Access Compliance Report

Public Rights-of-Way

(Curb Ramps)

Intersection ID: 54014	Main Street: SPEER_BV	Cross Street: ZILKER_PARK_DR	Location:	N
ADA ID: D79462A02FA2	Ramp Type: Directional1	Initial Pass/Fail: Pass	Overall Compliance: No	Severity Score: 5
Codes/Mitigation Info/Possible Solution		Field Measurements/Component Compliance

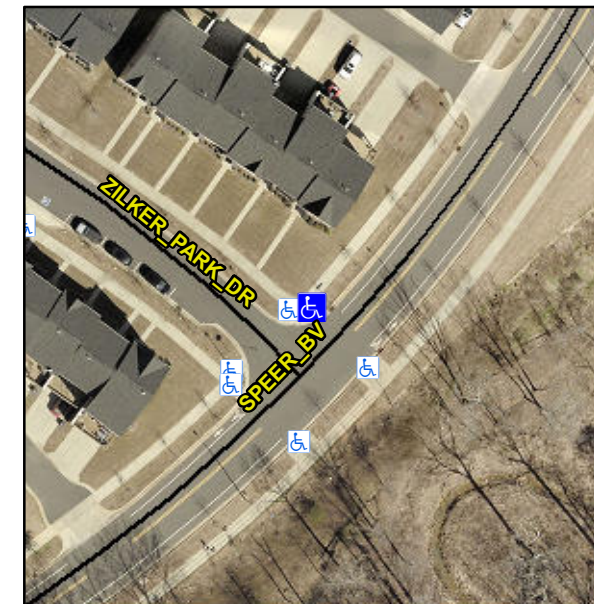
Remove & Replace Detectable Warning System. Remove & Replace Gutter.

R305.2, R304.5.4
